**Meeting of the Central Valley Flood Protection Board
August 26, 2011**

**Staff Report
Burlington Northern Santa Fe Railroad Company
Cross Creek, Kings County, CA**

Consider approval of Permit No. 18672 (Attachment B).

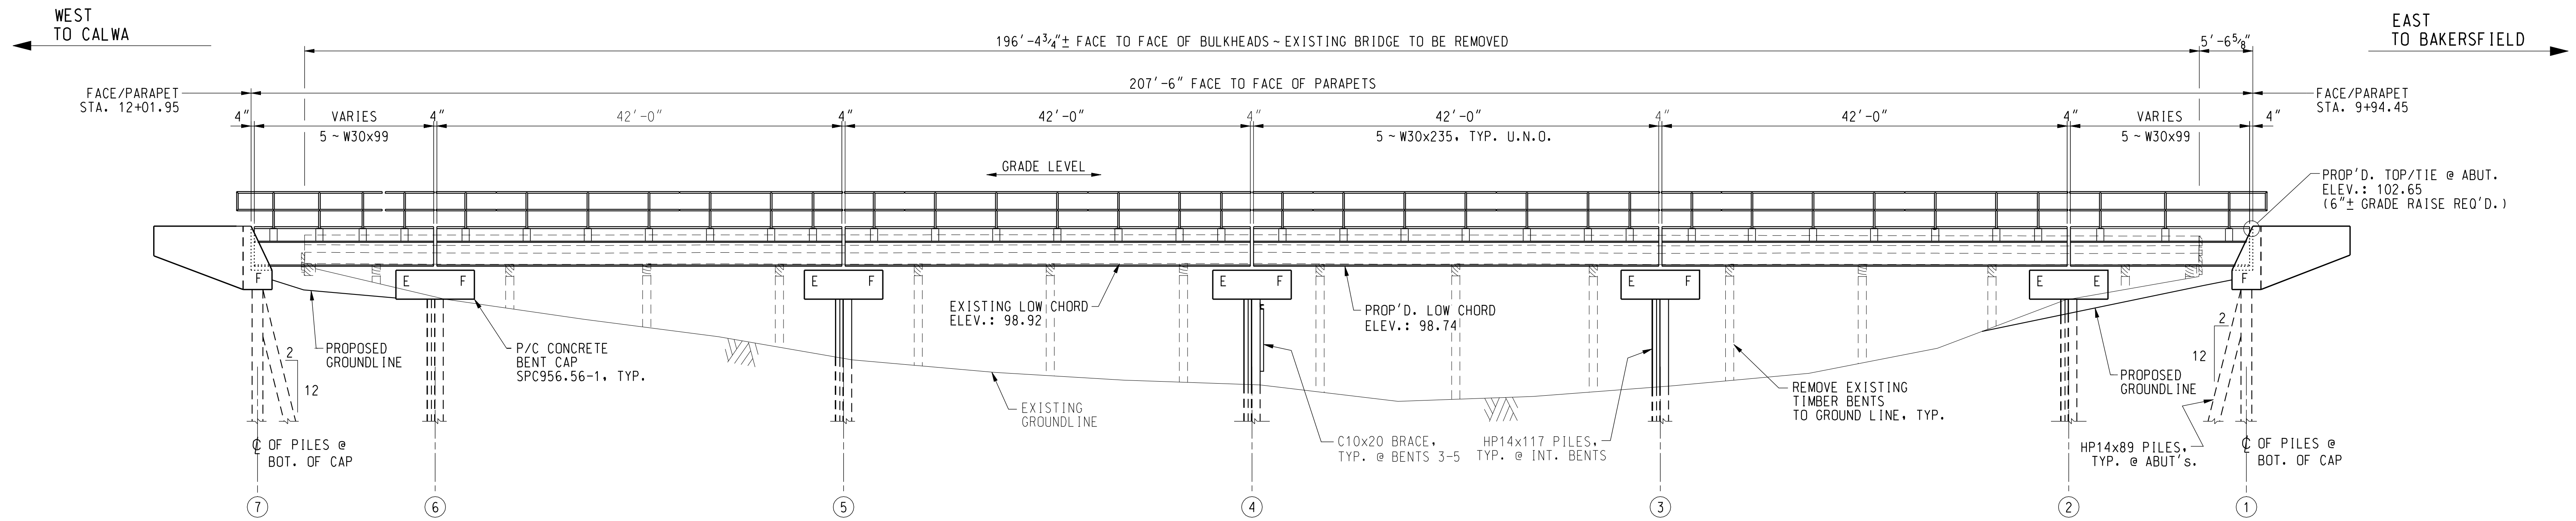
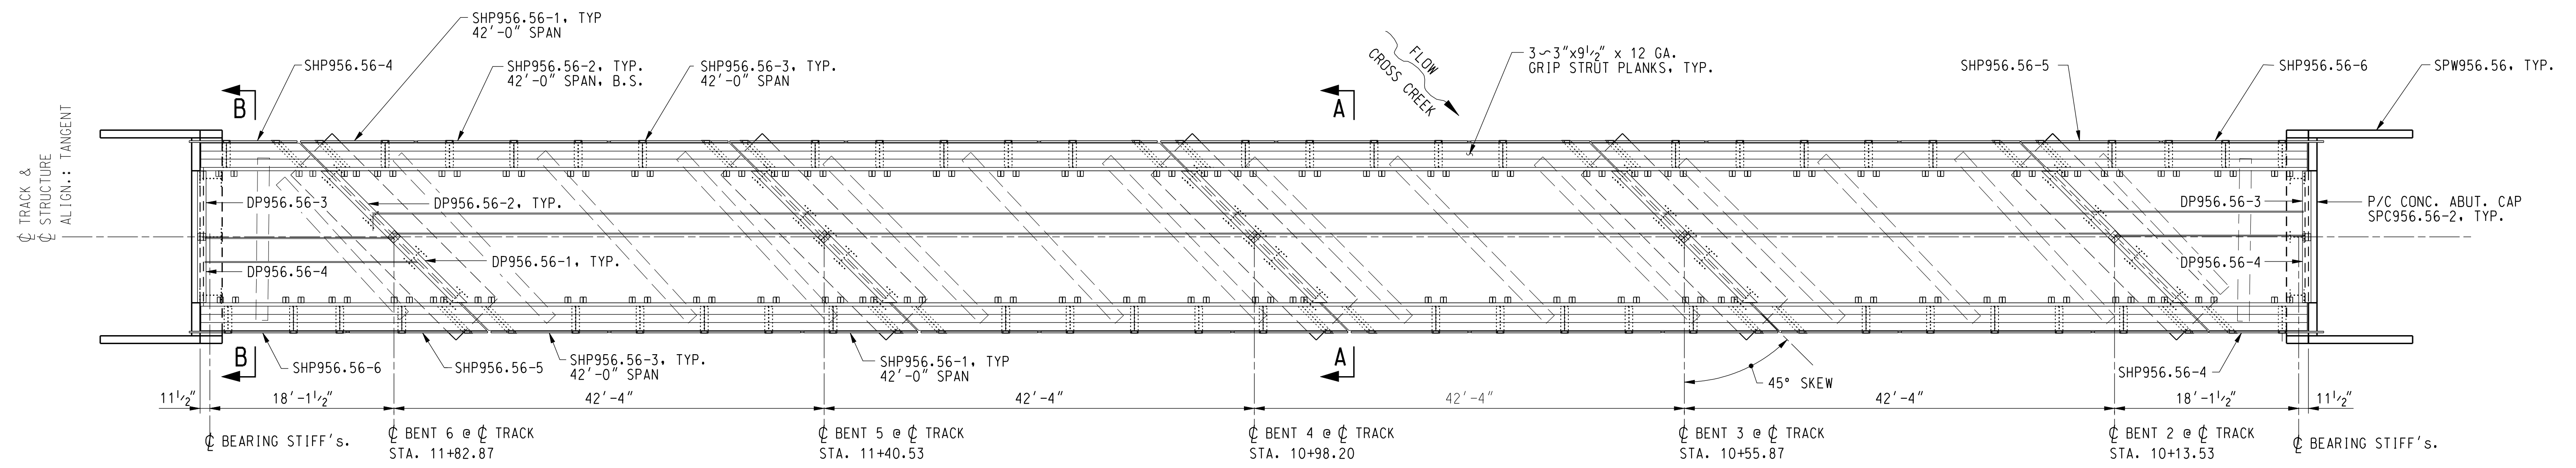
I'm writing you to request a variance to California Code of Regulations Section 128; (a); (10) (B) regarding the bottom structural members of the proposed bridge replacement relative to the existing bridge. Matching the low superstructure horizontal members (low chord) of the existing bridge will require a substantial track raise of the railroad bridge. It should be noted the proposed bridge will already be raised 6-inches to increase the low chord elevation, however the additional 5-inches required to match the existing low chord will require modification to existing at-grade crossings, public roads and infrastructure for several miles in each direction of the bridge. Therefore, due to railroad grade restraints substantially raising the BNSF track is not an option. It should also be noted, the dimension from top of tie to low chord is the minimum distance required to maintain the structural components for a steel beam bridge, which substantially increases the hydraulic efficiency of the bridge and decreases the risk of debris collection due to the longer spans.

I've included the complete set of construction drawings (sheets 1 through 15) for your use. Per your request, the 100-year Water Surface Elevation (WSE) is located on Sheet 1. Please find attached Table 1, which summarizes the existing and proposed bridge Water Surface Elevations (WSE). The hydraulic model extends 557 feet downstream of the bridge and results in no change to the 100-year WSE downstream of the bridge.

TWENTY-NINE: The soffit of the bridges shall have a minimum elevation of 211.37 feet. The vertical datum is NAVD 88.
